EGG-EA-5307

December 1980

TECHNICAL EVALUATION REPORT, ADEQUACY OF STATION
ELECTRICAL DISTRIBUTION SYSTEMS VOLTAGES, INDIAN
POINT NUCLEAR STATION, UNIT 2, DOCKET NO. 50-247

FIGURE 1. INDIAN POINT UNIT 2 ONE-LINE

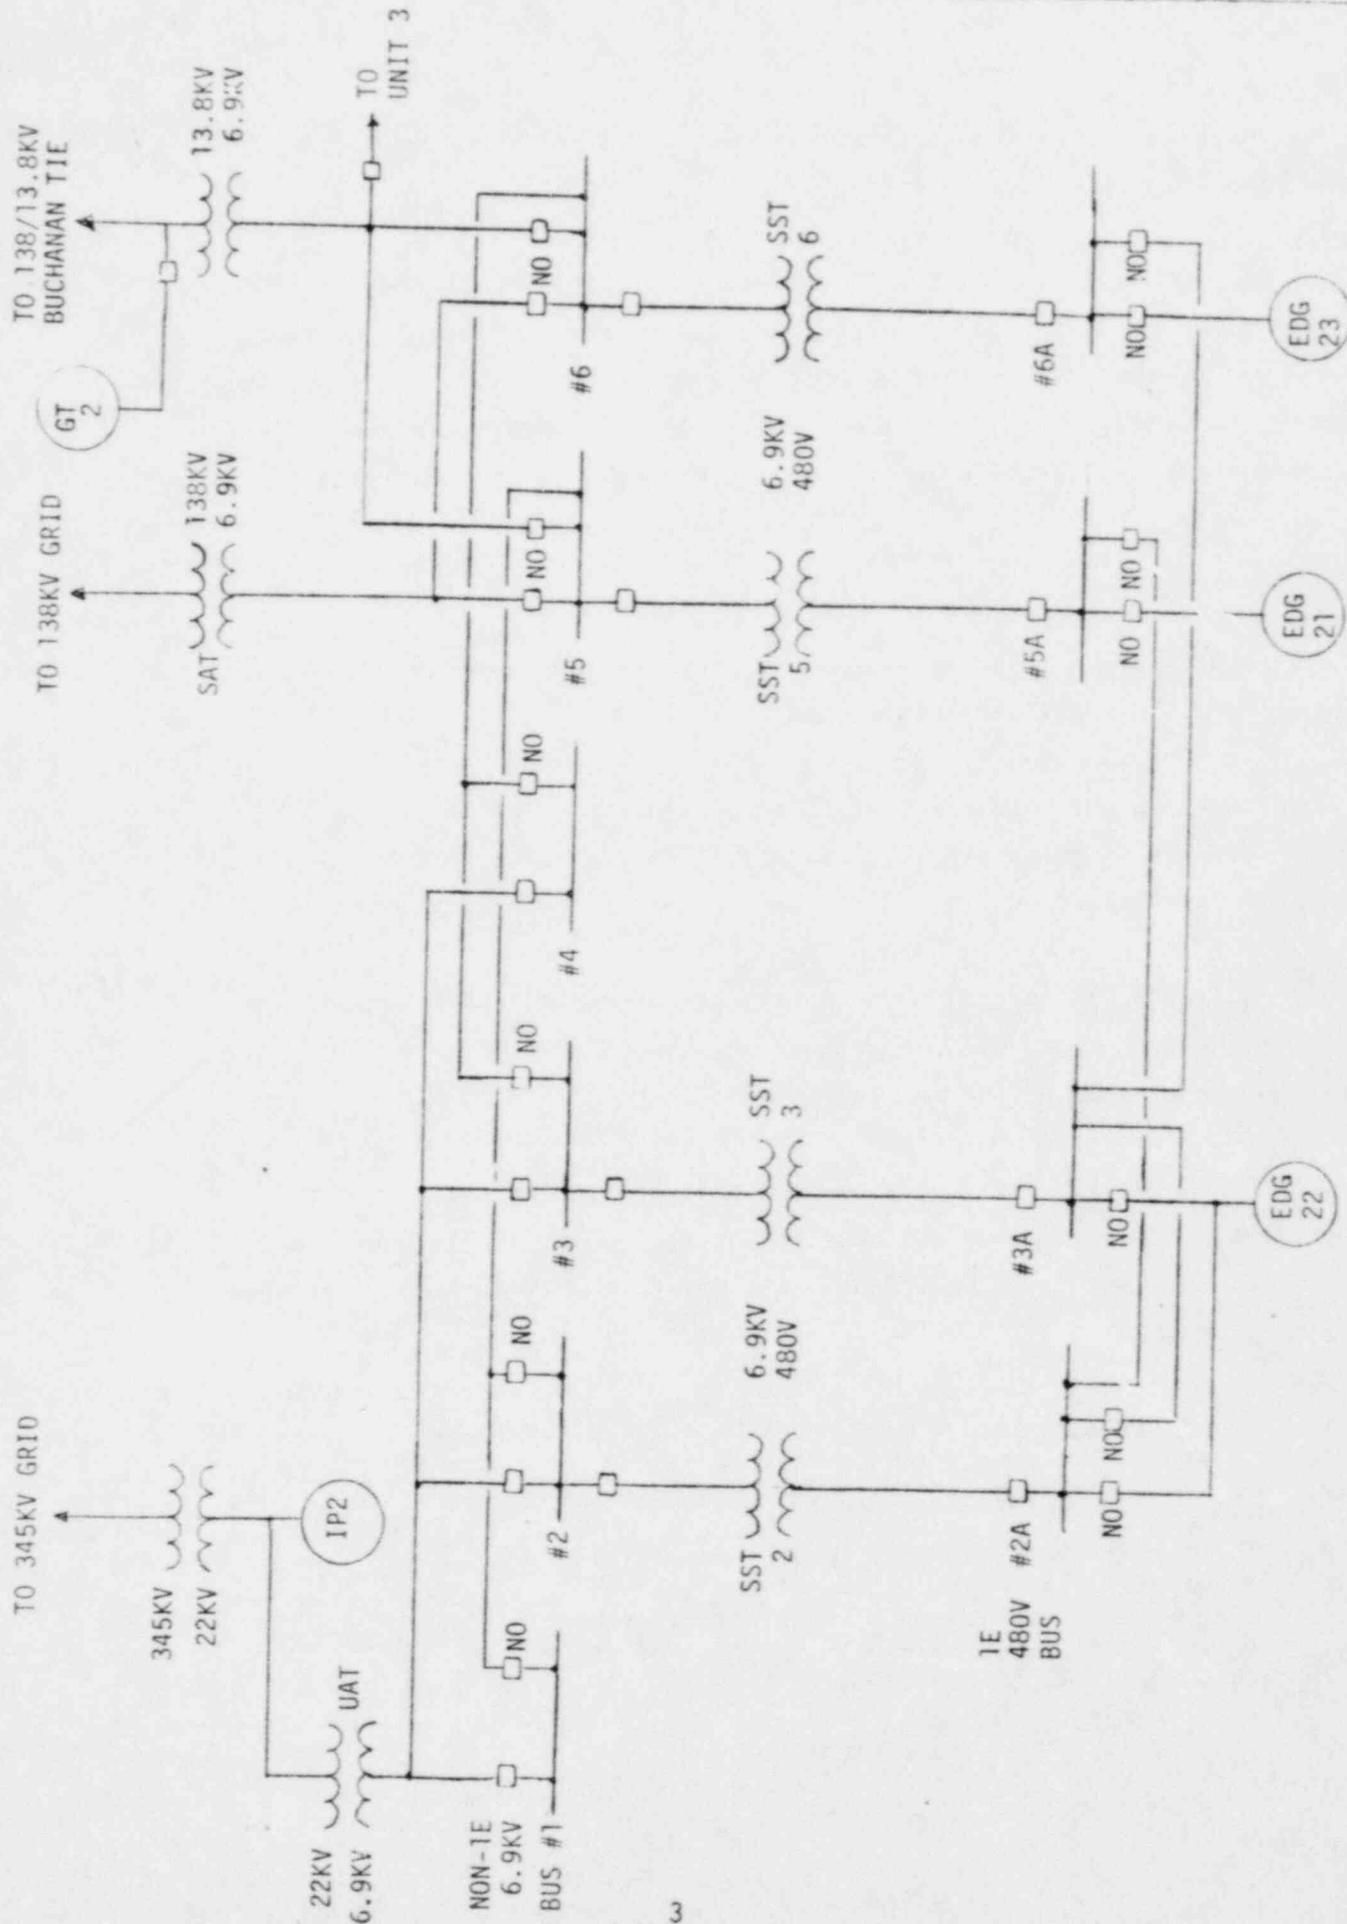
However, Con Ed has not provided analysis showing the capability and capacity of the 13.8kV system to supply all Unit 2 and Unit 3 loads through a Unit 2/Unit 3 tie breaker. There are no interlocks or limiting conditions of operation included in the plant Technical Specifications that prevent the use of the tie during operation of either plant.

Additionally, the Technical Specifications contain no limiting conditions to prevent the use of one or more gas turbine generators (GTs) from supplying all required 1E 480V loads via the 13.8/6.9kV transformer. Con Ed has not provided an analysis to demonstrate that the GTs are capable of starting and of continuously operating all required 1E equipment within the equipment voltage rating to either Unit 2 or both units via the Unit 2/Unit 3 tie breaker.

Indian Point is the site of two operating nuclear units. The preferred (138kV) and alternate (13.8kV) offsite sources are independently connected to the onsite distribution system of each unit. However, the alternate offsite source of each unit can simultaneously supply IE loads of the other unit through a tie breaker. Con Ed has not provided an analysis for the connection. Additionally, the Indian Point Station has three gas turbine generators that could supply power to class IE loads individually or in combination to one unit or both units through the tie breaker. No voltage analysis for this supply has been provided to the NRC.

- a. Con Ed should either provide an analysis to show that one 13.8kV gas turbine generator can supply satisfactory voltage to all possible connected IE loads (on both Units 2 and 3) or have LOC requirements in the Technical Specifications preventing their use.

- b. Con Ed should either provide an analysis to show that the Buchanan 138/13.8kV tie, through the 13.8/6.9kV transformer can supply all class IE equipment to both units through the Unit 2/Unit 3 tie breaker considering the Buchanan grid at its minimum expected voltage or provide LCO requirements in the technical specifications preventing the use of this tie breaker to IE loads during operation of both Unit 2 and 3.
